HOMESTAKE MINING COMPANY

Re: License No. SUA-1471

Homestake hereby requests an amendment to License Condition No. 19 concerning interim tailing stabilization and associated blown tailing/contaminated soil cleanup. The last half of Condition 19 has been completed and is proposed to be deleted. The correspondence referenced in the opening paragraph of condition 19 is no longer current and needs to be deleted and modified to reflect Homestake's current interim stabilization program.

HOMESTAKE TAILINGS INTERIM STABILIZATION PROGRAM

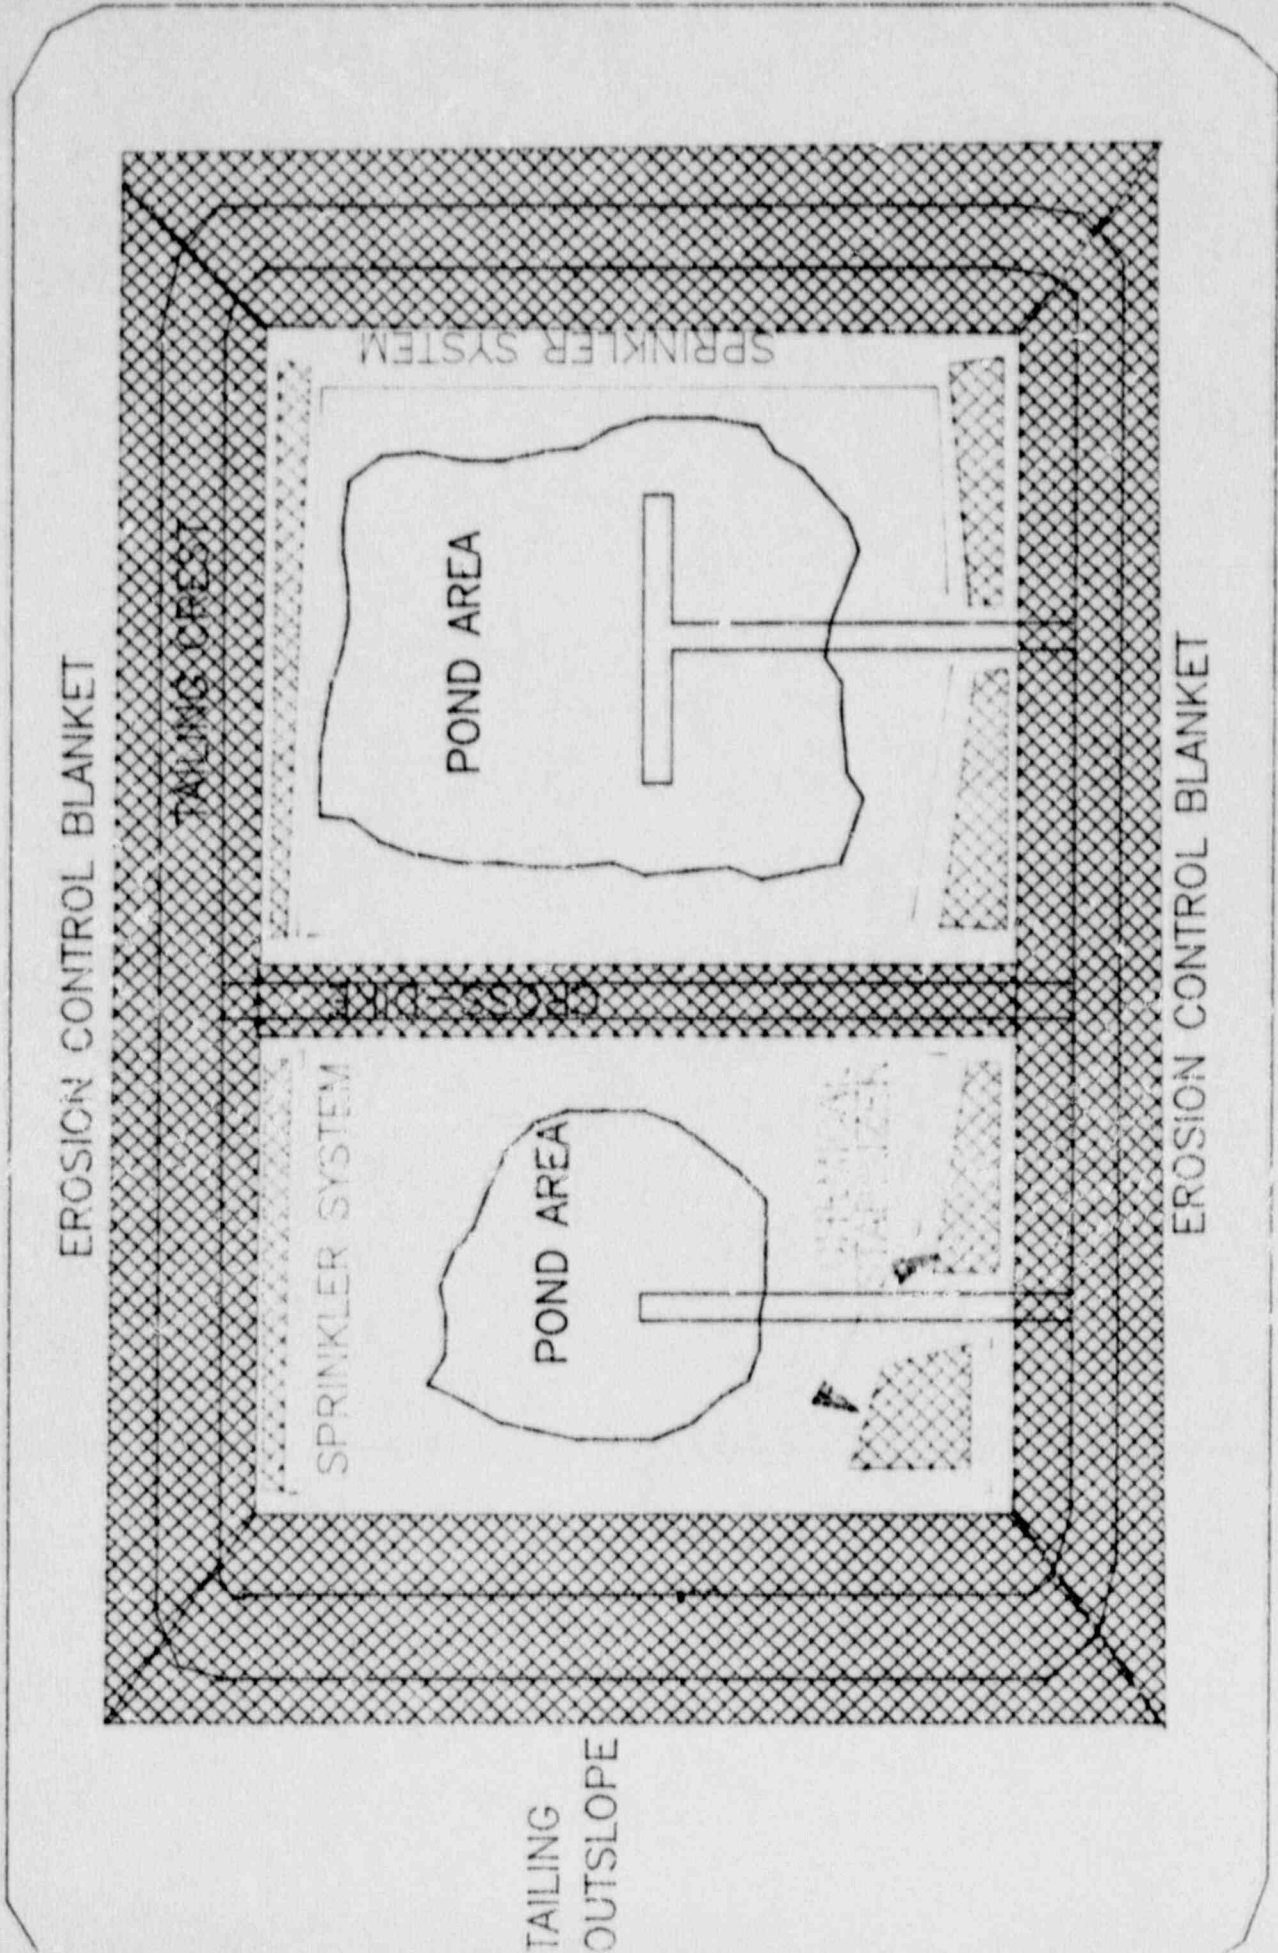
"19. The licensee shall implement an interim stabilization program for all tailings not covered by standing water as specified in the submittal dated February 16, 1989 and the schematic dated August 22, 1989 illustrating the dust control program, with the following additional requirements:
